**CORRESPONDENCE COVER SHEET
WASTE PERMITS DIVISION
TEXAS COMMISSION ON ENVIRONMENTAL QUALITY**

Date: May 17, 2019
 Facility Name: City of Kingsville Landfill
 Permit or Registration No.: MSW 235-C

Re: City of Kingsville Landfill – Kleberg County
Municipal Solid Waste (MSW) - Permit No. 235C
Permit Amendment Application – Supplemental Information
Tracking No. 23301130, 23458984, and 24040819; RN102334570/CN600674246

On behalf of the City of Kingsville and in response to your May 10, 2019 and May 16, 2019 email requesting supplemental information, we hereby submit the enclosed response regarding the Permit Amendment Application for the above referenced MSW facility.

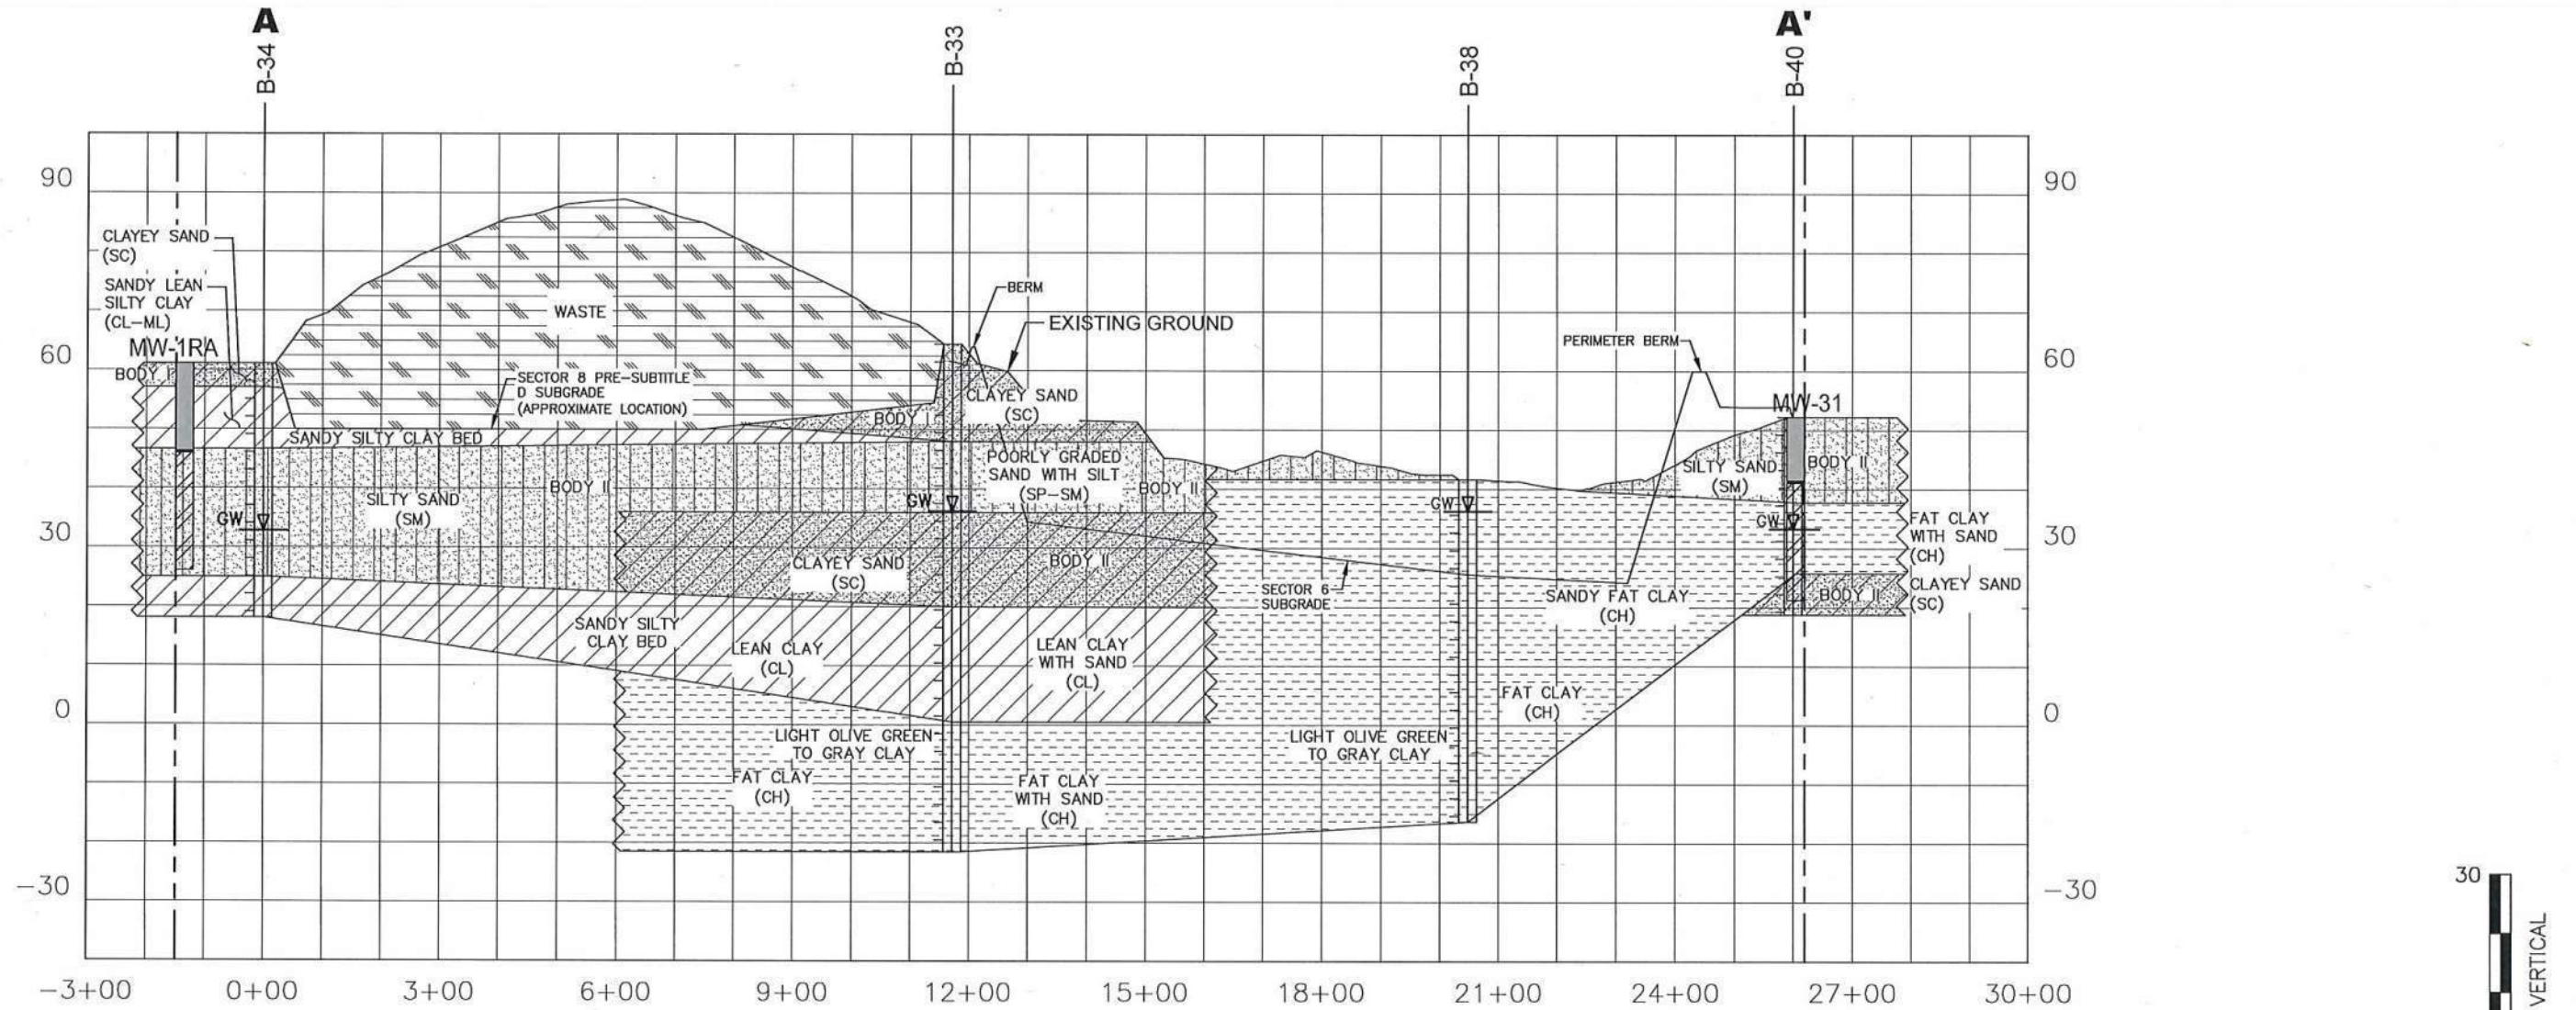
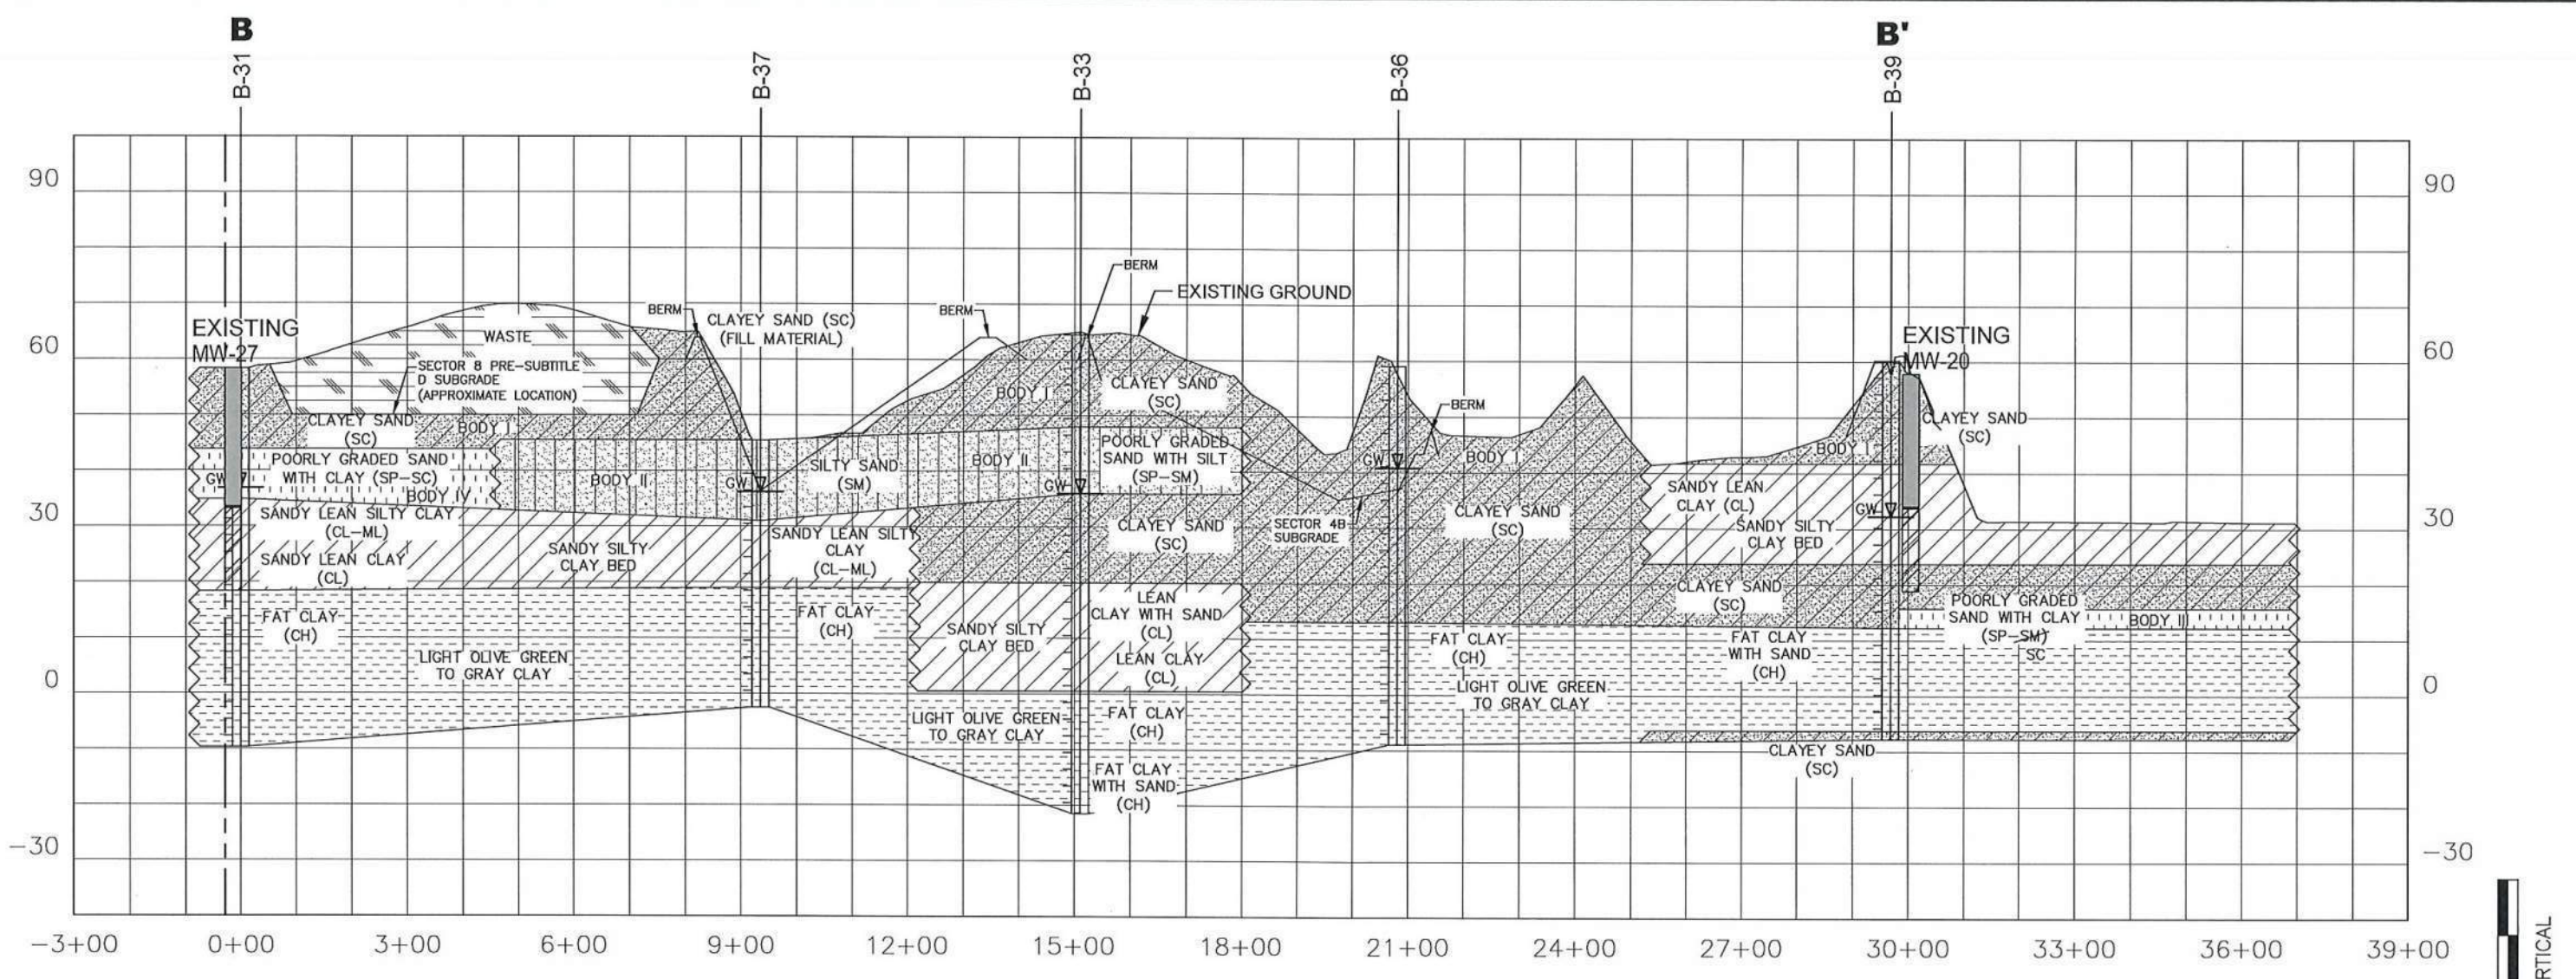
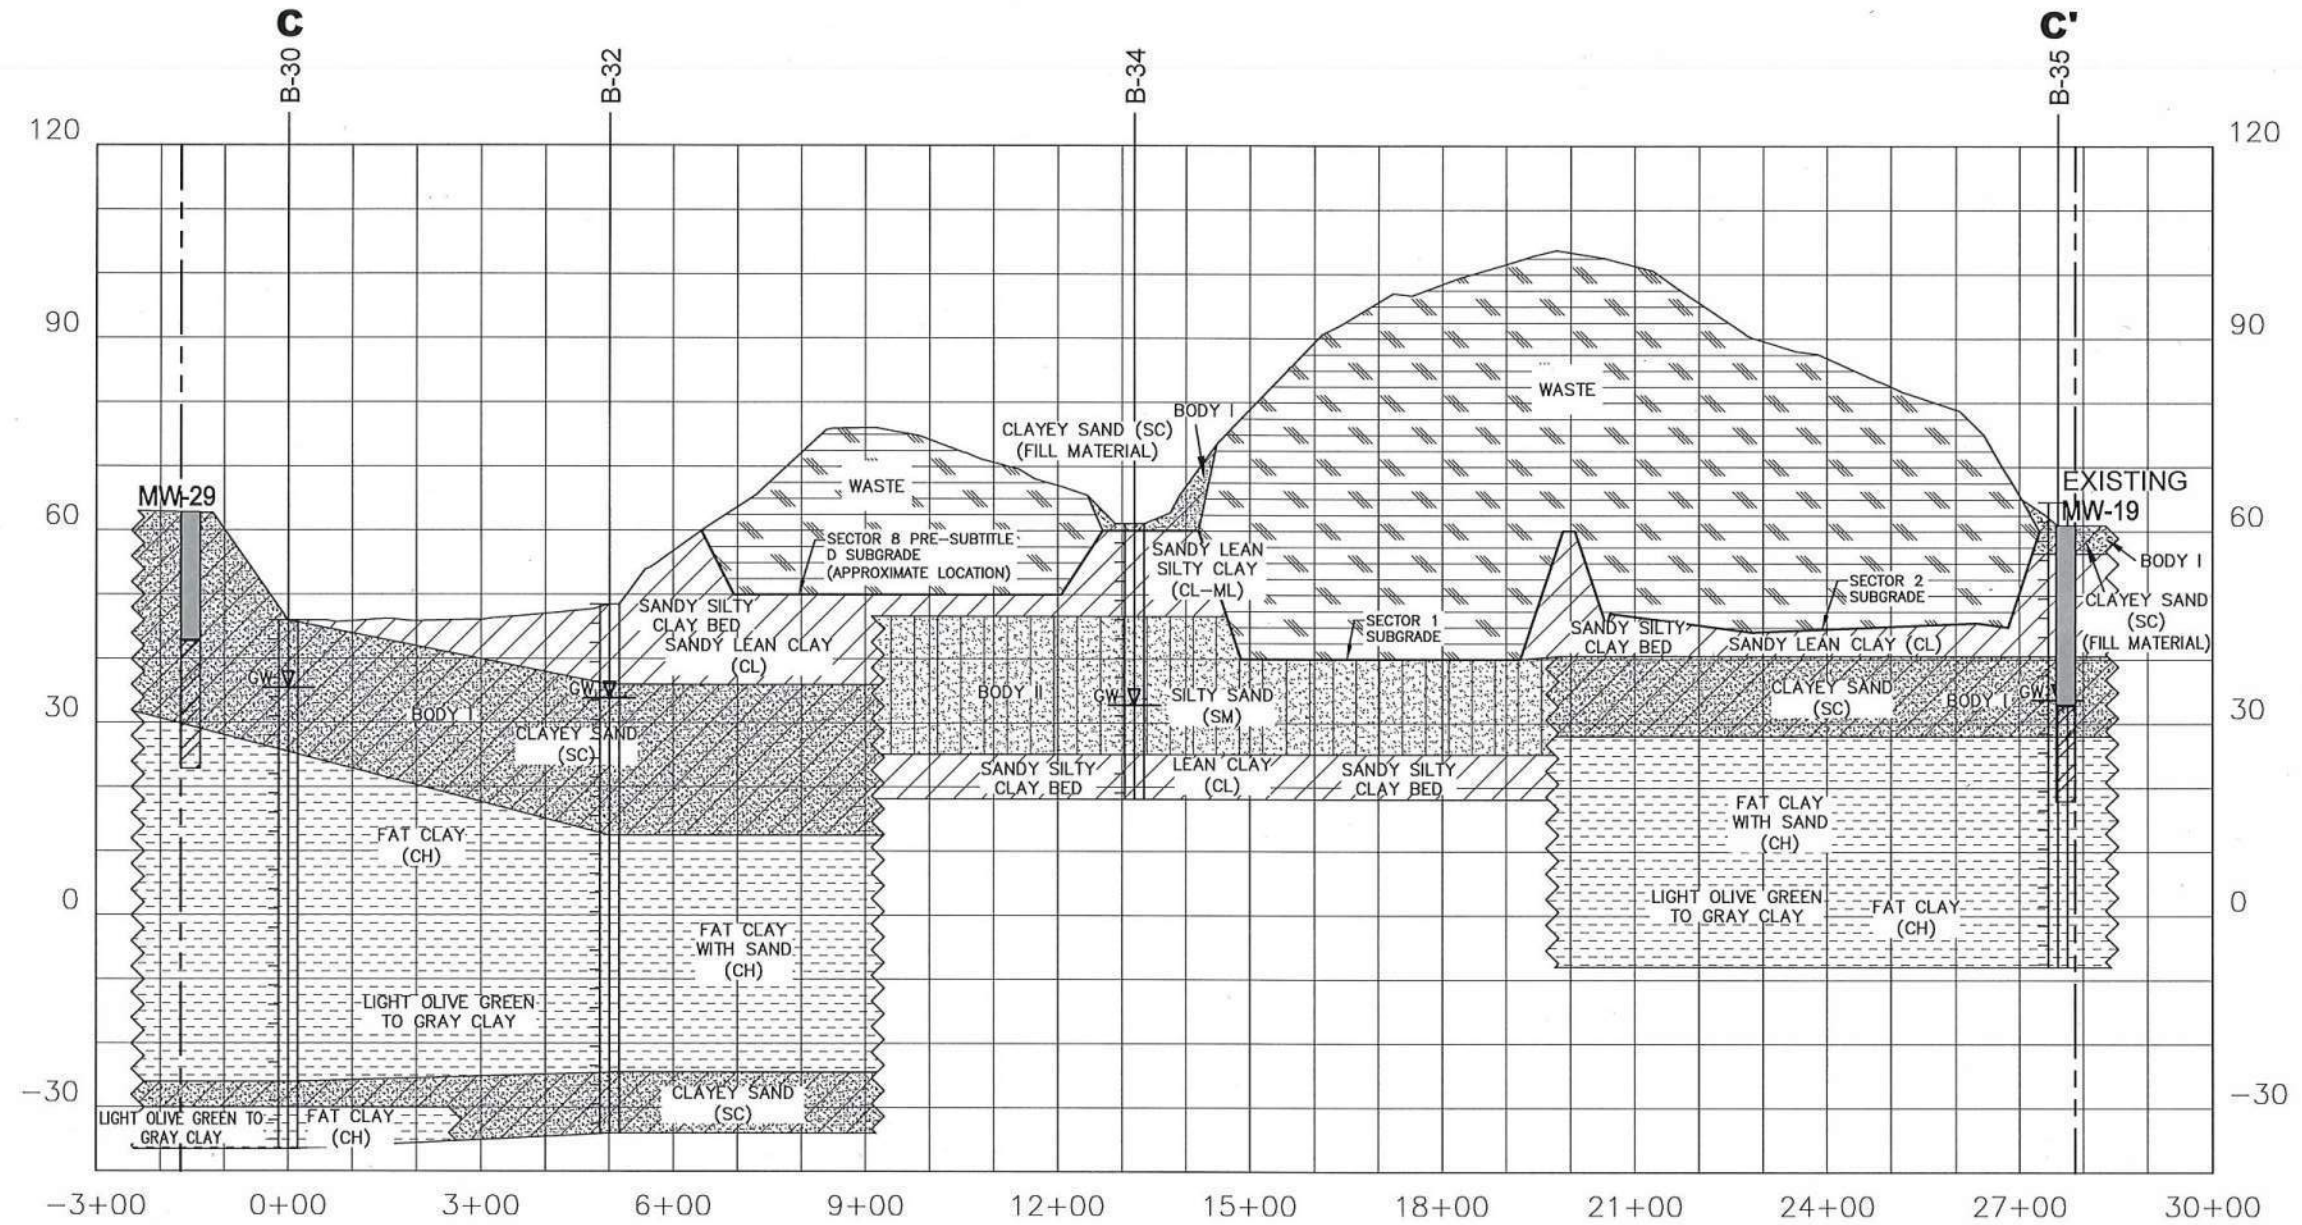
ID	Checklist Item	Citation
496	Submit cross-sections prepared from the borings; depicting the generalized strata at the facility. For small waste management units, two perpendicular cross-sections will normally suffice	330.63(e)(4)(G)
Location		NOD Type
Att 4, App 1, Sec 6.2.2, p. 64-79		Incomplete
NOD Description		
Revise the Hanson cross sections in Att 4 to show existing and proposed groundwater monitor wells that are on or close enough to the lines to show on cross sections; include screened intervals. Also show existing and future landfill base grades.

The Hanson cross sections in Attachment 4 have been revised to show existing and proposed groundwater monitor wells that are on or close enough to the lines to show on cross sections; screened intervals have been included. Existing and future landfill base grades have also been added.
